D. C. COOK - UNIT 1

Attachment No. 3 to AEP:NRC:0665

Summary of the Effect on the D. C. Cook Unit 2 ECCS Analysis

Figure 3-2-2  $K(Z) - \text{Normalized } F_Q(Z)$  As A Function of Core Height

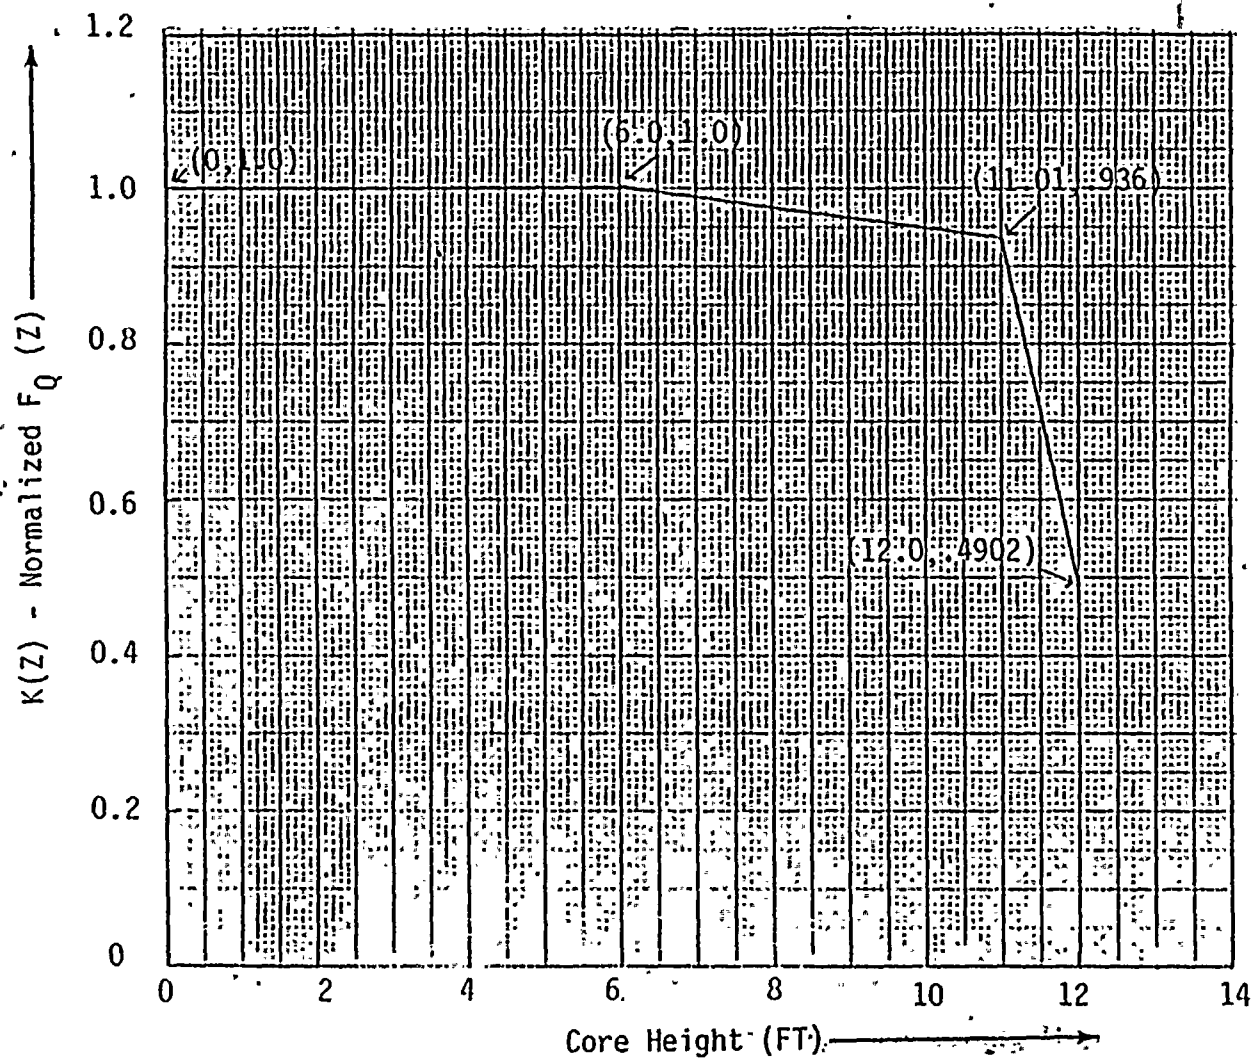
$V(Z)$  is the function defined in Figure 3.2-3,  $K(Z)$  is defined in Figure 3.2-2,  $T(E_\ell)$  is defined in Figures 3.2-3a and 3.2-3b,  $P$  is the fraction of RATED THERMAL POWER.  $E_p(Z)$  is an uncertainty factor to account for the reduction in the  $F_Q^L(E_\ell)$  curve due to an accumulation of exposure prior to the next flux map.

- $F_j(Z)$  is the normalized axial power distribution from thimble  $j$  at core elevation  $Z$ .
- $P_L$  is the fraction of RATED THERMAL POWER.
- $K(Z)$  is the function obtained from Figure 3.2-2 for a given core height location.
- $\bar{R}_j$ , for thimble  $j$ , is determined from at least  $n=6$  in-core flux maps covering the full configuration of permissible rod patterns at 100% or APL (whichever is less) of RATED THERMAL POWER in accordance with:

Figure 3.2.3a

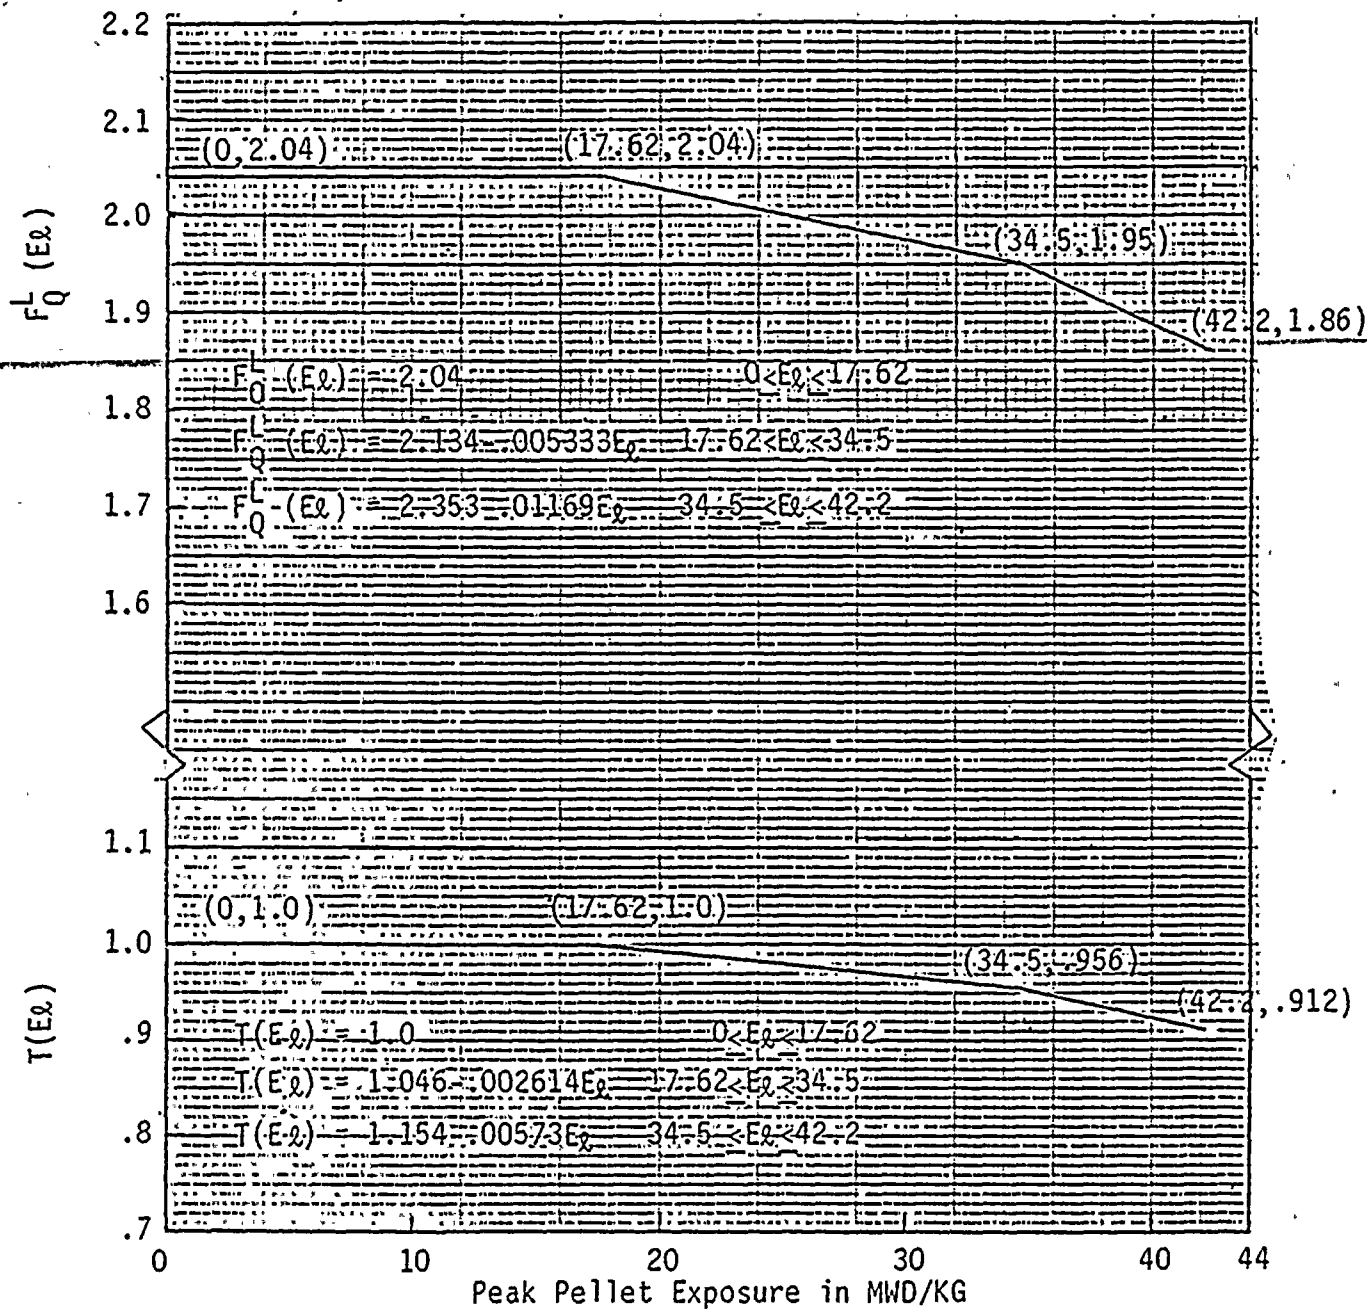
- $F_{Qiz}^{Meas}$  is the limiting total peaking factor in flux map  $i$ . The limiting total peaking factor is that factor with least margin to the  $F_Q^L(Ez)$  curve defined in Figure 3.2-3a for Exxon Nuclear Company fuel and in Figure 3.2-3b for Westinghouse fuel.

$T(E_2)$  is the ratio of the exposure dependent  $F_Q^L(E)$  to 2.04 and is defined in Figure 3.2-3a for fuel supplied by Exxon Nuclear Company and in Figure 3.2-3b for fuel supplied by Westinghouse Electric Corporation.
